European tyre and Rim  
Technical Organization

# ETRTO considerations on the proposed R51 amendment

November 15<sup>th</sup> 2021

Figure A.2 — Examples for the most relevant parameters

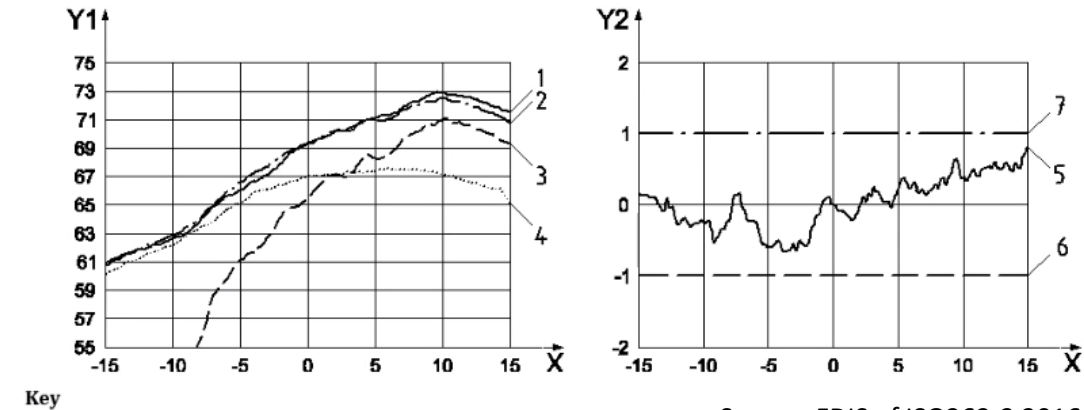
- › With the proposed implementation of case 2 the influence of using different vehicles on different tracks has a negative impact on the measurement uncertainty of  $L_{urban}$  since  $L_{crs\_tr}$  is determined with the measurement uncertainty of an R117 test
- › ETRTO asks OICA to present data to show that the proposed case 2 would be equivalent to the current implementation of the vehicle homologation
- › Maximum power train noise and maximum tyre rolling noise usually do not occur at the same position on the test track. Case 2 energetically adds the two maximum values which could lead to a general overestimation of vehicle noise. Would a peak position correction be an option for the evaluation?
- › Does subtracting the maximum value of tyre noise from the overall vehicle noise without considering the position on the track, minimizes the measured powertrain noise?
